Sanction to repairs to the Mitawali Math building at Kharaj

MUZRAI DEPARTMENT.

SUBJECT:— Repairs to the Sri Uttaradi Math building at Holenarasipur

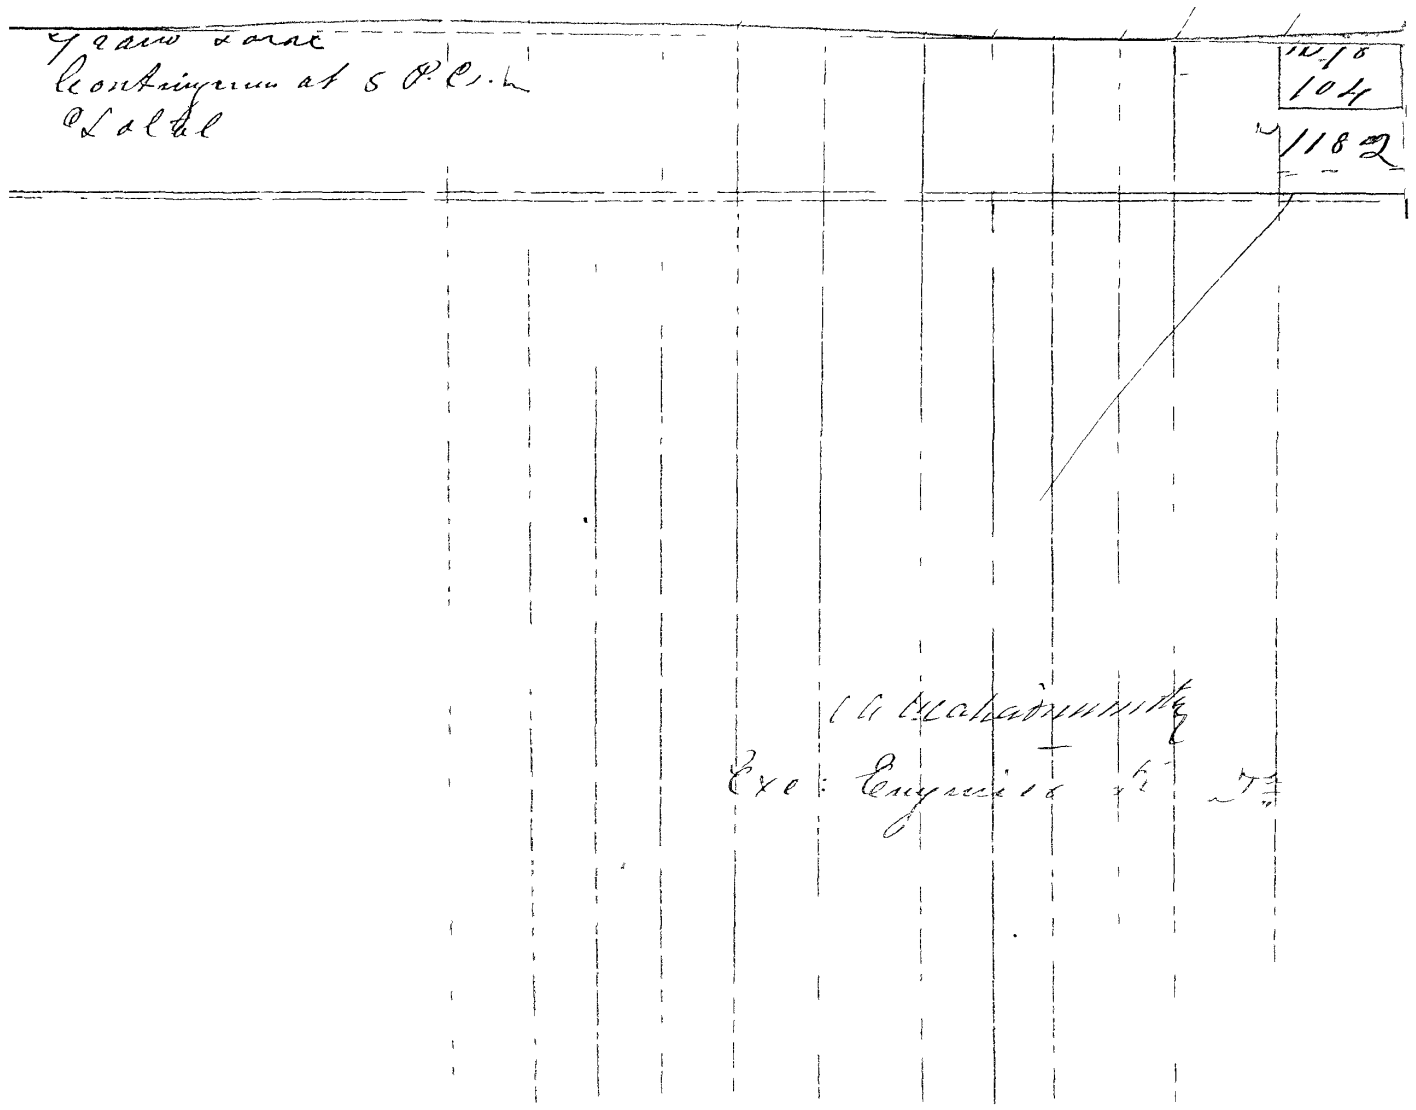
Particulars of Work	No.	Dimensions			Total Qty	Per	Rate			Cost	Total
Improvements to Bhandara (1)											
(a) Dismantling the undermining wall between Bhandara and the east room	1	10	2	10	200						
Total cft						200	cft	.	.	4	4
Brick with Mud wall	1	8	1'' 8	11'' 2	103						
Total cft						103	cft	.	2	8	12
Plastering with Chunnam	2	8	1.2	.	192						
Total Sqs:						1.92	Sqs.	3	.	.	6
(b) Providing Racks for books. Bk Stands	4	10	1'' 2	16''	60						
Total Rft						60	Rft	.	6	.	22
Iron cross pieces or angles	1	12	7		84						
Total Rft						84	Rft	.	6	.	31
Soldering & fixing &c Planks	1/2		6''			12	Each		12	.	9
	6	6'' 2	1'' 2	1'' 2	7'' 2						
Total cft						7'' 2	cft	3	8	.	26
Carving Stone & Japanning iron &c	1/2			R							1
Tal.											116

Removing Steps in the Back Square (11)													
Woman Ring walls.	2	7	1 3/4	1	98	98	cft	.	.	1	2		
Building up do into arches.	2	.	.	.	.	2	Each	1	.	.	2		
Steps Slabs.	2×2	×	3×1½		18	18	Sft	.	6	.	6		
Building Below Steps	2									R.	2		
Total													12
Removing & Refixing Doors. (12)													
Removing the 2 Doors and refixing them Below Staircase	2	1	6								5		
Brick in Mud wall to sides	2	10	1½	10	300								
deduct Doors	2	6	3	1½	54								
Balance						246	cft	.	2	3	34		
Planking on Ad Common	2×2	10	10	.	400	1,00 & 200		3	.	.	12		
Wooden Railing round the Staircase	2	20	2½	4	100	100	Lft	.	8	.	50		
Total													101
Providing Saw Windows. Besides 12 Windows provided for 38 Windows are required. (Scaffolding)	38	2	3½	.	266	266	Sft	1	8	.	399		
Inserting those with Sill & Lintel					38	38	Lin	5	.	.	190		
Total													589
Enclosure ~~Entrance~~ wall including Foundation (14)	1	250	1½	9	3375	3375	cft	.	.	6	105

Coping with Tiles & Common	1	250	3½	.	875	875	Lin	18	.	.	130		
Repairs Lane & Them	R.	&	R.								25		
Total													26
